CITY OF PUNTA GORDA ADA TRANSITION PLAN FINAL REPORT Herald Court Centre

October 4, 2017

Figure 4-1 – 2nd Floor Parking Area

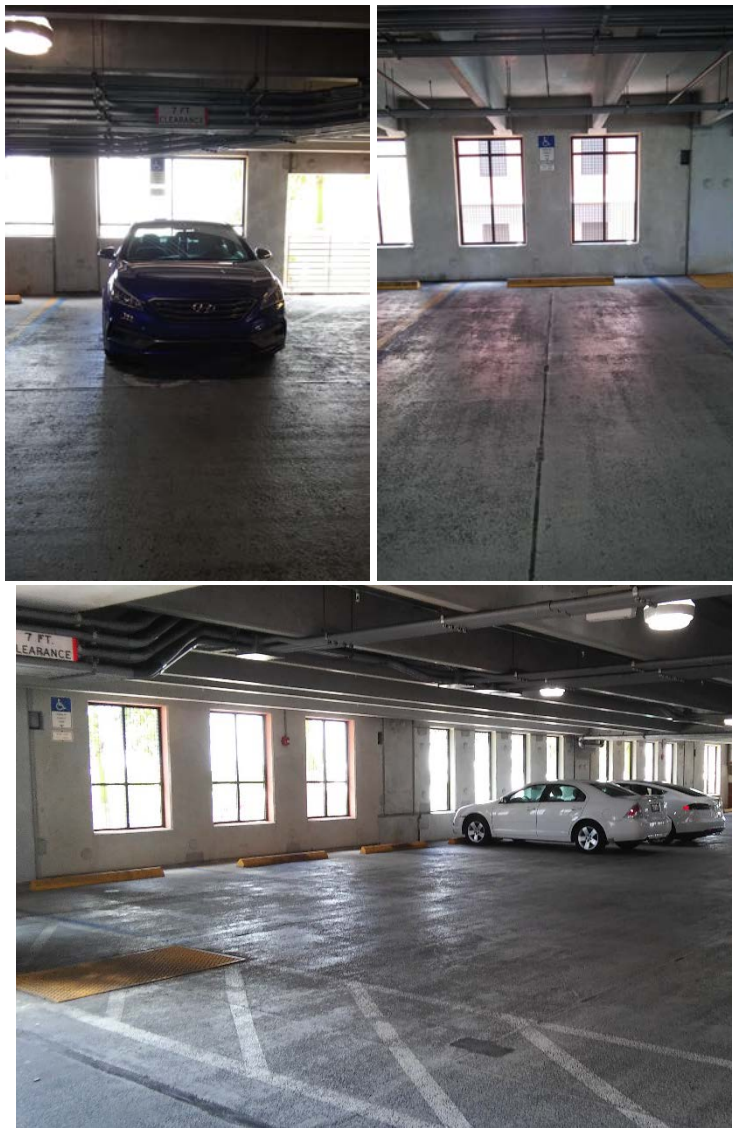
- The striping and ISA symbols are fading.
- The width of the accessible parking spaces are less than 144” wide, violating **FAC 502.2**.
- The access aisles have detectable warning unnecessarily placed on them.

- The width of the marked accessible route narrows to 30" for 36" in length.

- Restripe and repaint the faded parking spaces and ISA symbols.
- The width of the accessible parking spaces must be 144 minimum, per **FAC 502.2**. The adjacent access aisle must be 60" minimum, per **FAC 502.3.1**.
 - Note, **ADAAG 502.1** states that "Where parking spaces or access aisles are not adjacent to another parking space or access aisle, measurements shall be permitted to include the full width of the line defining the parking space or access aisle."
- Remove all detectable warning from the access aisles and accessible route within the parking garage.
- Although the width of the marked accessible route narrows to 30" for 36" in length, a portion of the vehicular traffic lane can be utilized. Widening the marked accessible route, while not required, would provide additional safety benefits, per **FAC 502.3**.

Figure 4-6 – Protruding Objects

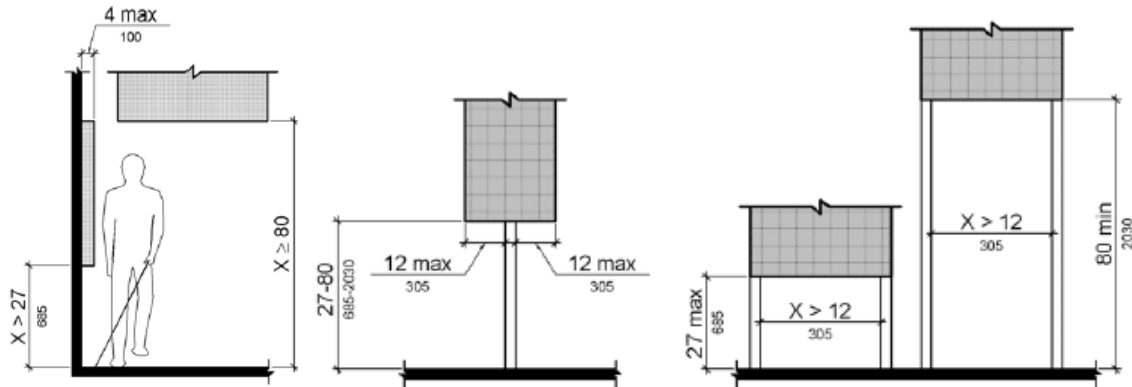
A protruding object, as pictured below, are objects that extend out into the accessible route greater than 4" at a height greater 27 and less than or equal to 80", per **ADAAG 307.1**. In addition, a post-mounted object can overhang the circulation path no greater than 12" at a height of 27" to 80", per **ADAAG 307.3**.

Figure 4-7 – Protruding Objects

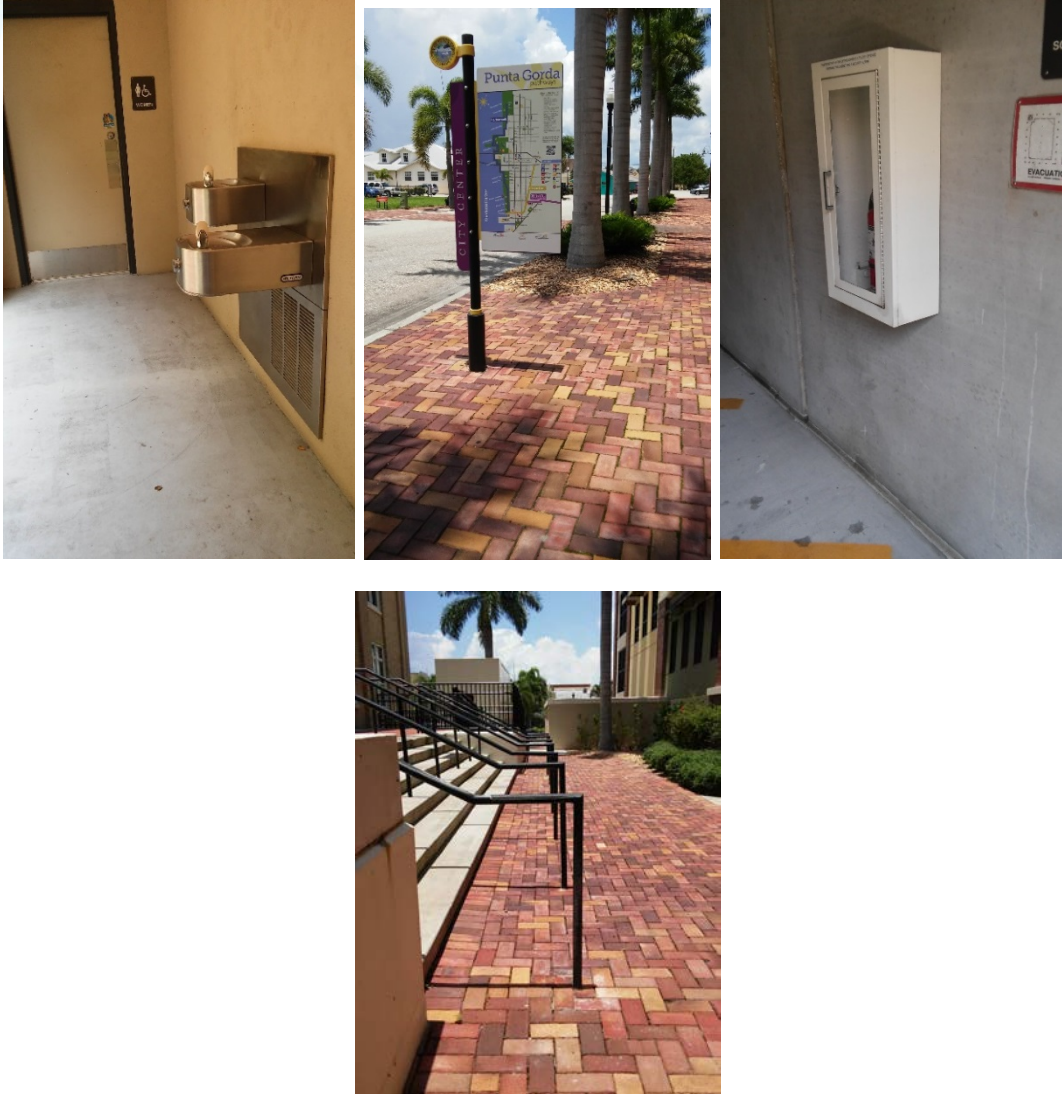
- The low water fountains, adjacent to the restrooms on the first floor protrudes from the wall 17” at a height of 27.5”.
- The high water fountains, adjacent to the restrooms on the first floor protrudes from the wall 12” at a height of 34”.
- The pathway sign adjacent to the road protrudes out 24” at a height of 35”.
- The fire extinguisher, located by the southwest stairwell, protrudes out 7” at a height of 33”.
- The handrails leading to the adjacent historic courthouse property, which is owned and maintained by the Charlotte County Board of County Commissioners, protrude out 24” at a height of 36”.

- Recess the water fountains or add a cane apron or fountain skirt under them so they do not protrude into the circulation path per **ADAAG 307.2**.
- Relocate the pathway sign so as to be centered on the pole and therefore not protrude beyond 12” on either side of the pole, per **ADAAG 307.3**. Or, extend the sign so that the bottom of the sign is less than 27” above the ground.
- Either relocate the fire extinguisher so that the bottom edge is less than 27” above the ground per **ADAAG 307.2** or add a pipe or a similar barrier below the fire extinguisher box to make it cane detectable.
- Charlotte County BOCC must either shorten the handrail extension to be no more than 12” in length or add an additional section of handrail, parallel to the existing extension connecting to the vertical section at a height no greater than 27”.

Figure 4-8 – Accessible Route

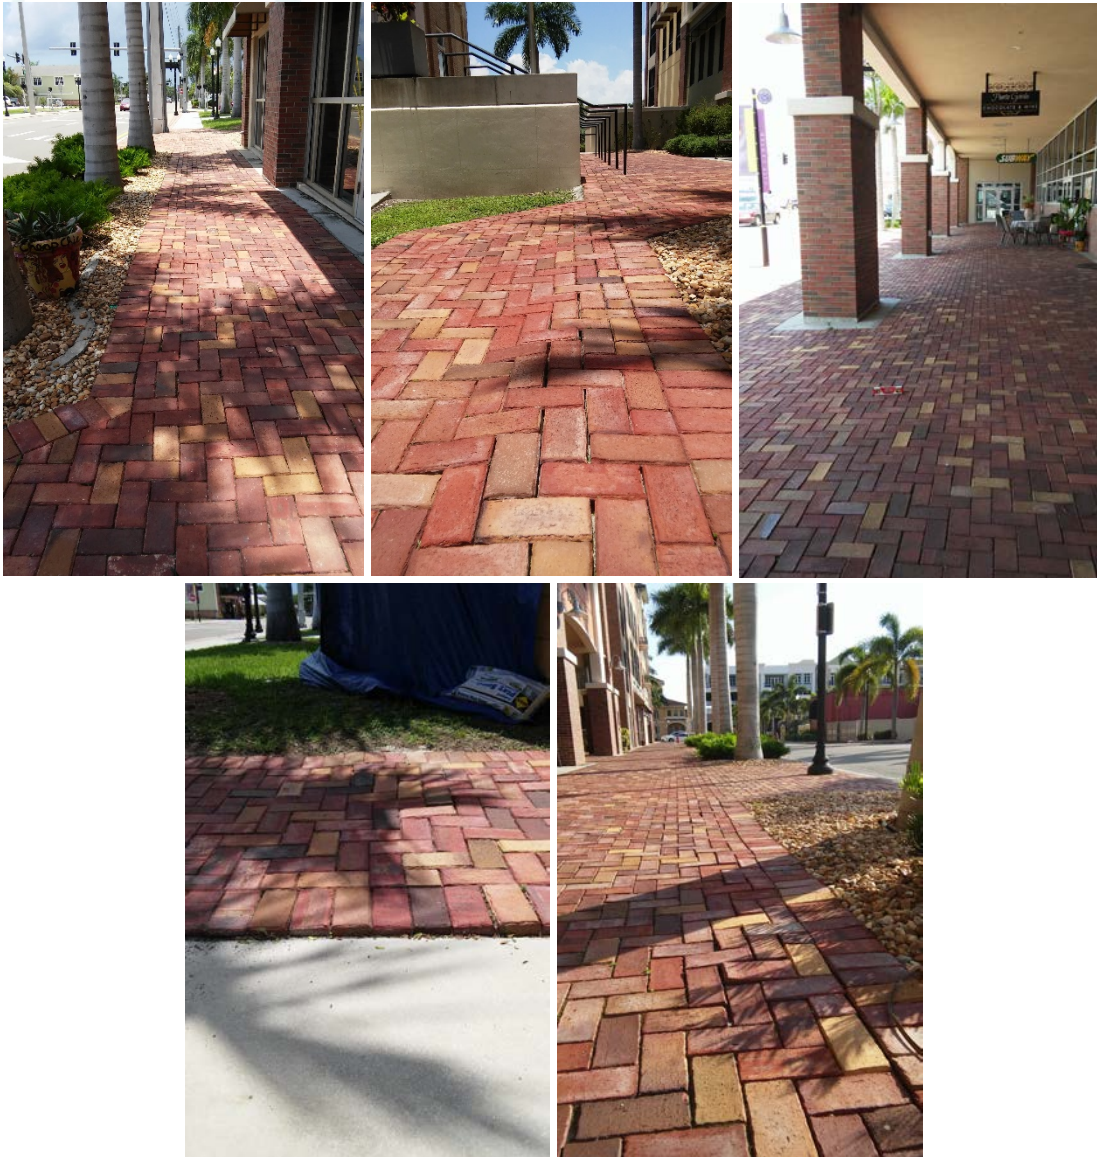
- The brick walkway, shown in the first photo, on the south side of the parking facility, adjacent to the Artisans store has a cross slope of 6%, violating **ADAAG 403.3**.
- The second photo shows the brick path adjacent to the rear of the courthouse, which has a running slope of 6%, violating **ADAAG 403.3**.
- The third photo, on the north-east side of the facility, adjacent to US-41, has an 8% cross slope, violating **ADAAG 403.3**
- The last two photos show two locations where there are tripping hazards due to the bricks not settling in an even and level manner, , violating **ADAAG 303**.

- Resurface the brick walkway around the perimeter of the parking garage to have a running slope no greater than 5% and a cross slope no greater than 2%, per **ADAAG 403.3**.
 - An accessible route is required to be a minimum of 36" wide and have 60" passing spaces every 200', per **ADAAG 403.5.1** and **ADAAG 403.5.3**. While it is not required that the entire width of the walkway be of compliant slope, at its current configuration it is difficult for people to distinguish where it is safe to traverse and where there are barriers to accessibility.
- Resurface any tripping hazards so they are no higher than 0.25" high or 0.5" high if beveled, per **ADAAG 303**.
